Access Compliance Report

Public Rights-of-Way

(Curb Ramps)

Intersection ID: 11262	Main Street: SHAMROCK_DR	Cross Street: EASTWAY_DR	Location: SE
ADA ID: 9B4A351693D1	Ramp Type: BlendTrans1	Initial Pass/Fail: Pass	Overall Compliance: No
		Severity Score: 2.75

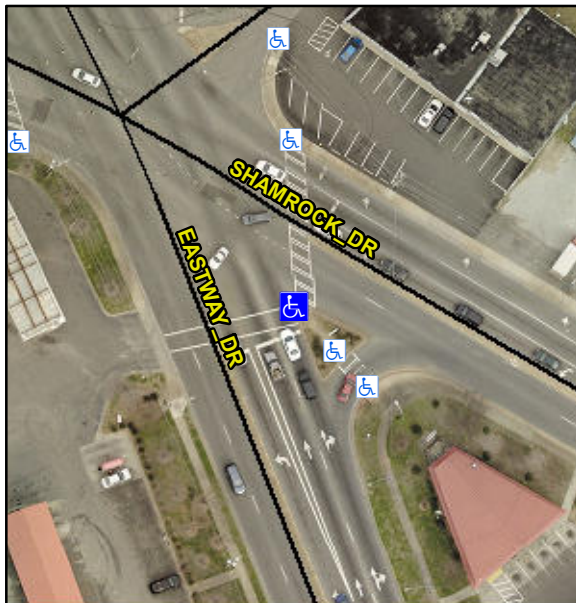
LOCATED ON ISLAND

Not Found, R305.1.4

Remove & Replace Curb Ramp With Two New Directional Ramps or Equivalent. Restripe Crosswalk(s) To Provide Clear space.
